# Discussion of Nico van Waes' comment LB11a-151

IEEE C802.16d-03/47

To present the details of HIPERMAN changes, which Nico's comment proposes to adopt.

# Resolution (11)

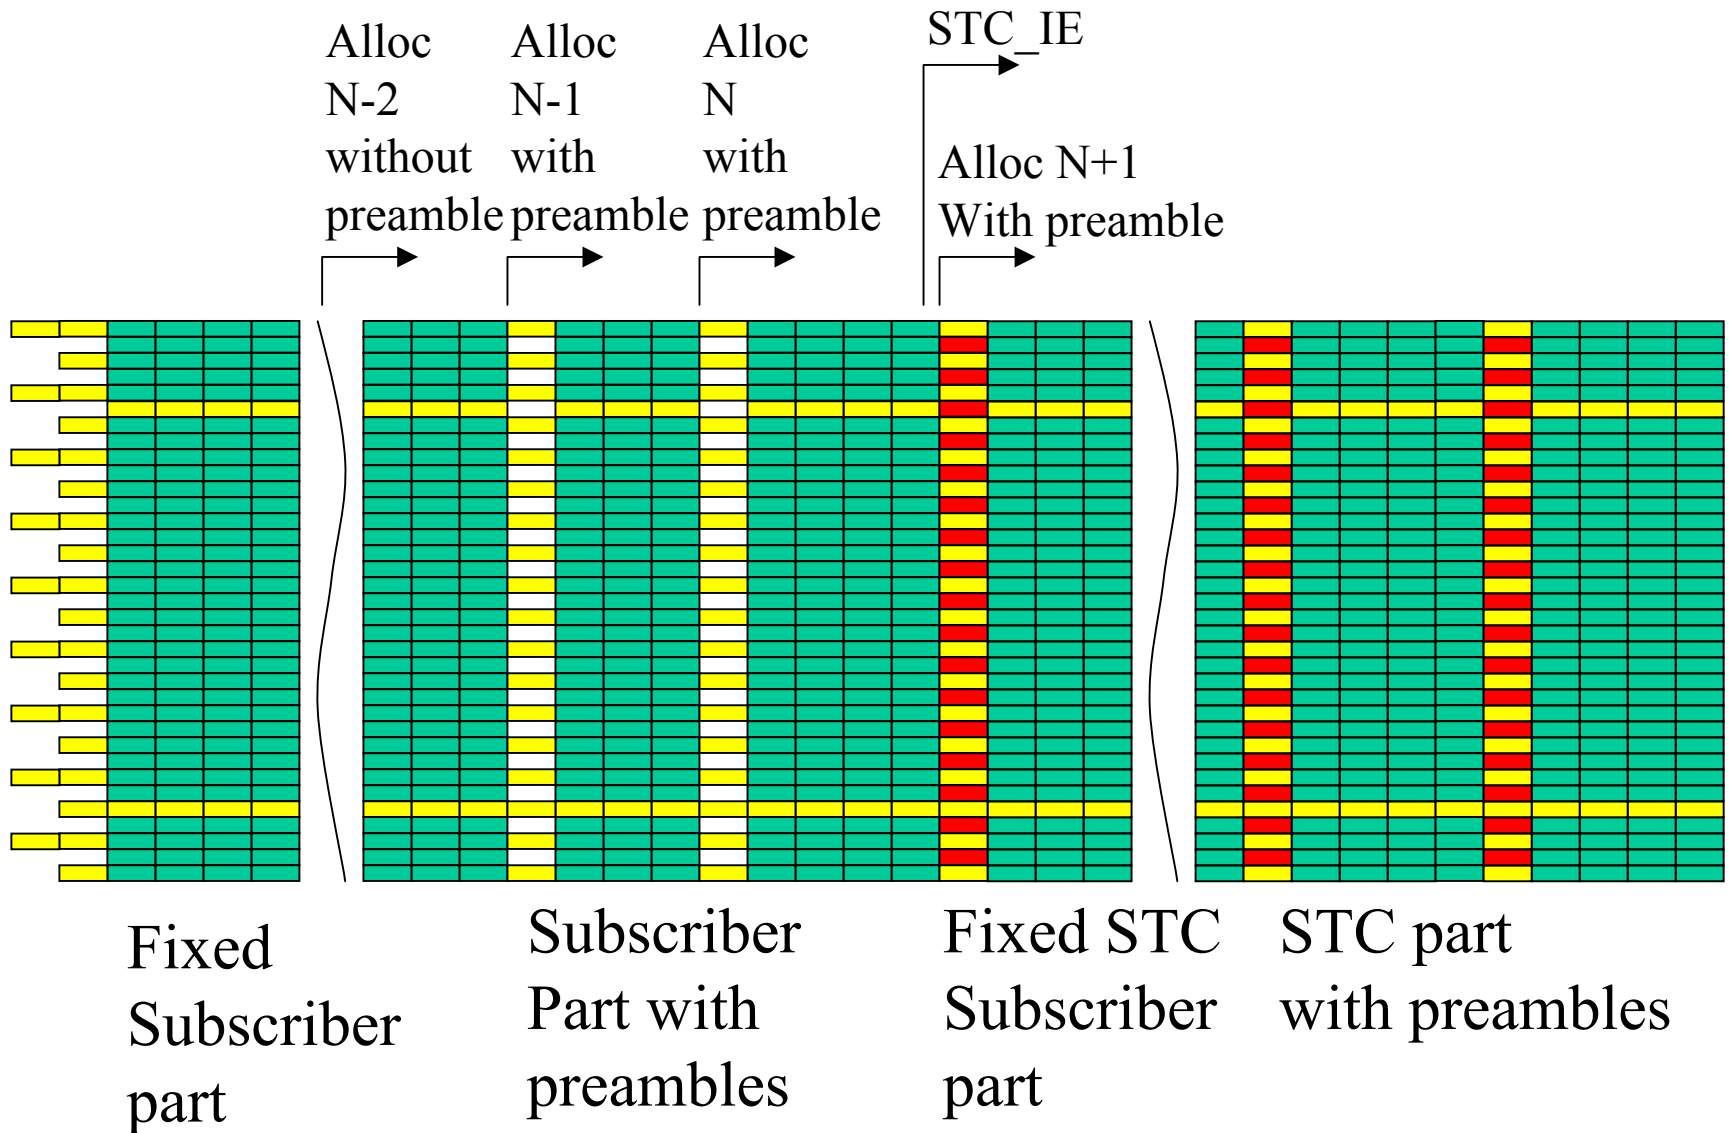
- Modify 8.4.4.3 in accordance with ETSI BRAN dts\_102177v000008p, section 6.3 and update the frame duration codes in 12.2 to match.
- Duration codes
  - Addressed also in Tal's comment 141
  - Use spec such as #frames per second is an integer
    - 2.5, 4, 5, 8, 10, 15.625, 20 msec
